Senate Finance and Public Administration Legislation Committee —Budget Estimates Hearing—May 2011

Answers to Questions on Notice

Topic: **Disability Access**

ACCESSIBILITY REVIEW

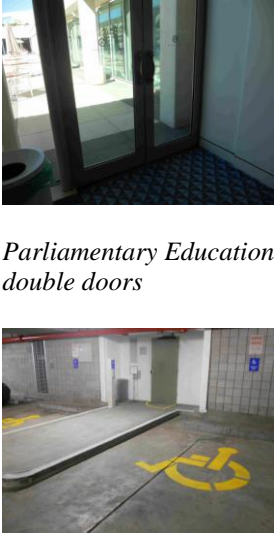
3	Security gates	<p>Devise and implement a management plan requiring staff at security entry points to assist a person in a wheelchair pass through the security gates if and when required.</p> <p>Devise and implement a management plan for the provision at the earliest possible opportunity of security gates with a minimum clear width of 850mm (1000mm preferred) at each secured main entrance.</p>	N/A

No	Item	Recommendation(s)	Photo
		<p><i>Rationale:</i> A security gate is akin to a doorway. A clear width of 850mm is required under AS1428.1(2009) for doorways that are required to be accessible.</p>	
Emergency Egress			
4	Emergency egress plan	<p>Prepare and implement an emergency management plan for the implementation of strategies to facilitate emergency egress for people with a disability. Any such plan should incorporate use of fire wardens. The conducting of drills at regular intervals in which such plans are deployed, assessed, and refined is recommended. A twice-yearly drill has been suggested in previous access reviews.</p>	N/A
Paths of Travel			
5	Stairways – stair nosings	<p>Provision of permanent indicative contrasting strips that are compliant with AS 1428.1 on each stair tread of the two forecourt stairways is strongly recommended. The current strips are painted strips and, as such, require regular maintenance.</p> <p><i>Rationale:</i> Safety – A contrasting nosing is critical for people with limited vision to locate the riser.</p>	 <p><i>Forecourt stairways – painted strips have a tendency to wear out over time.</i></p>

A28 EPCR (Blue Room)

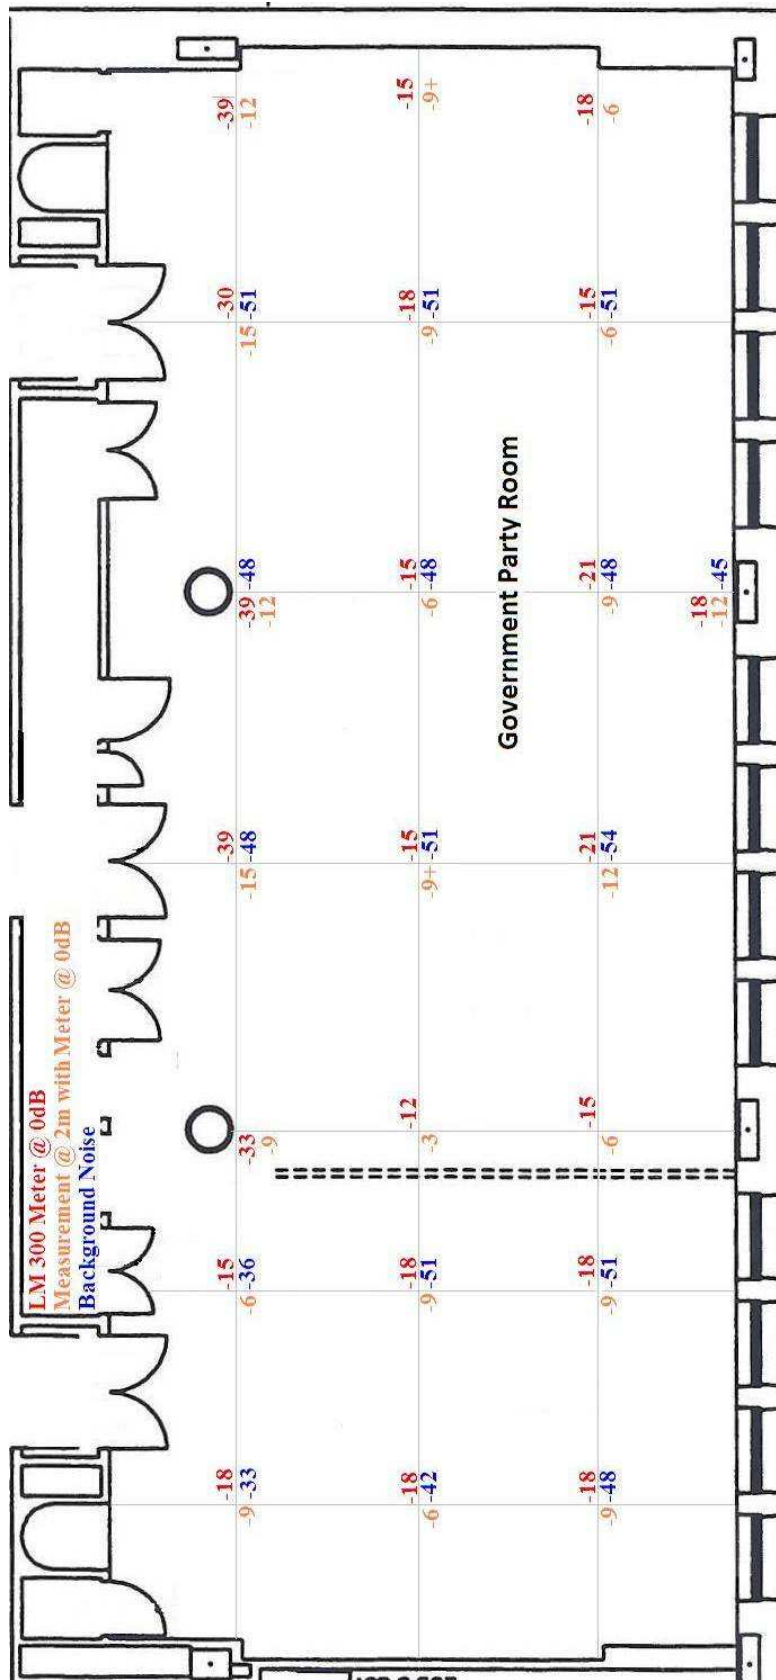
Note: This room has a number of Television Studio Lamps and associated mains wiring which produces above normal amounts of Hum.

There is a sharp rise in The North East corner (top right)

A31 Cabinet Room

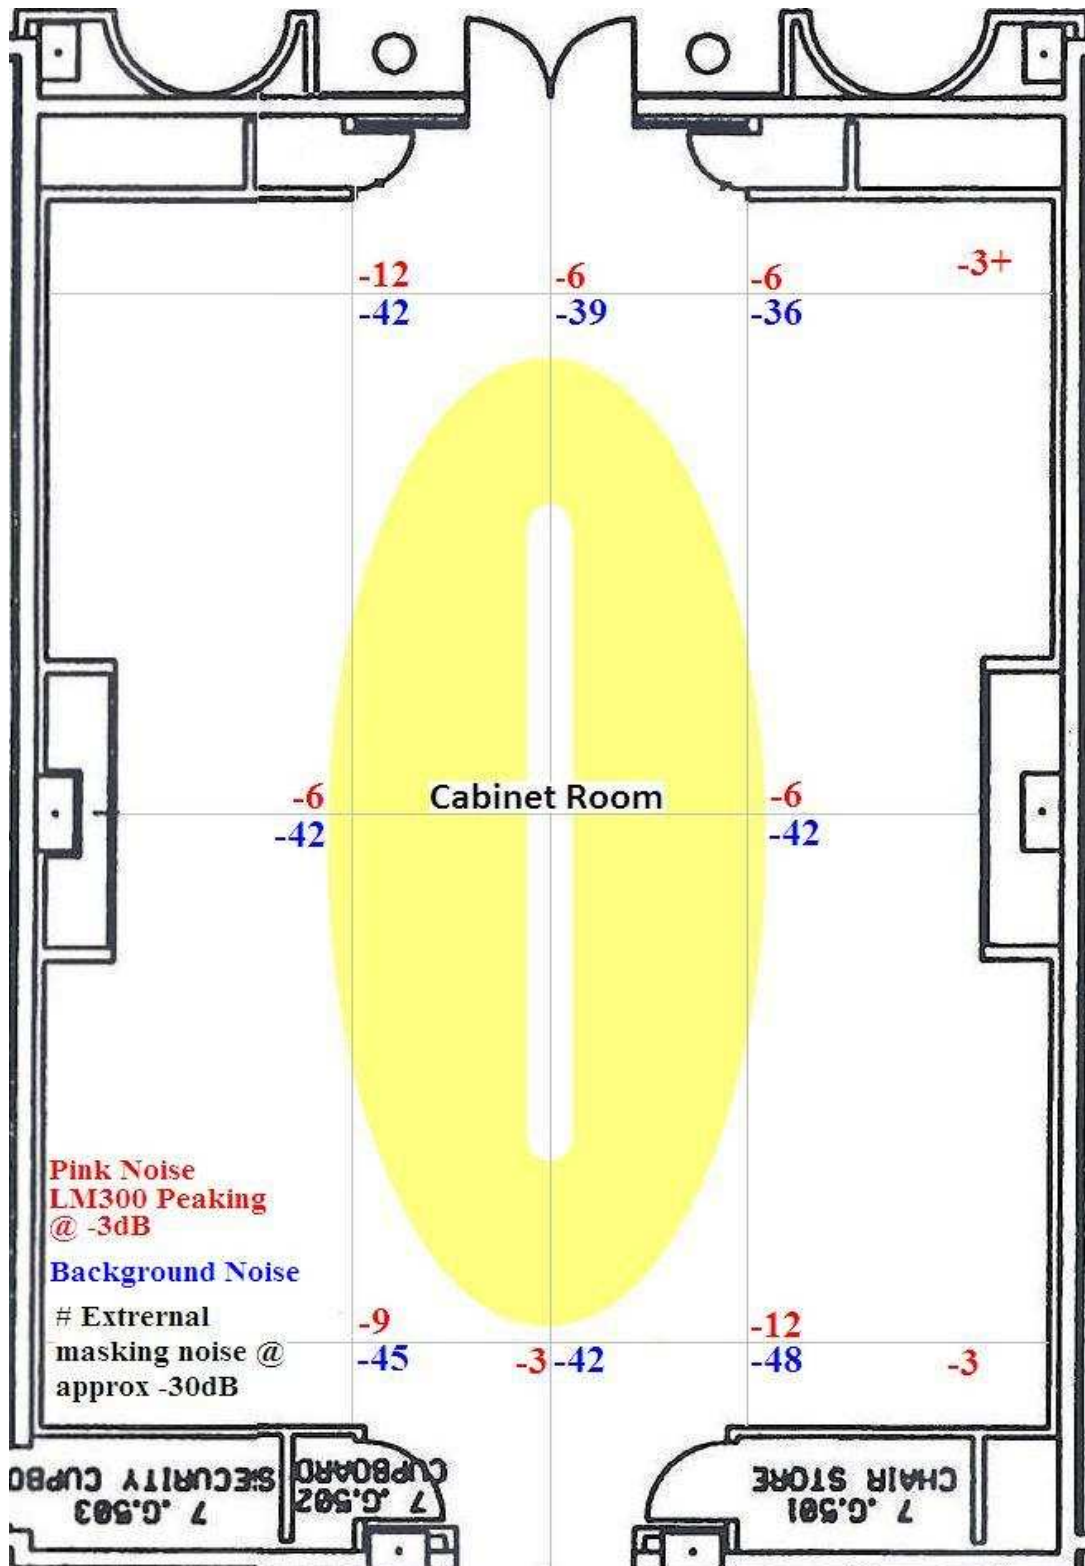
Due to system integrity issues, this room was only partially tested with a low level pink noise source. During commissioning and certification by T4, this venue was compliant to a very stringent standard.
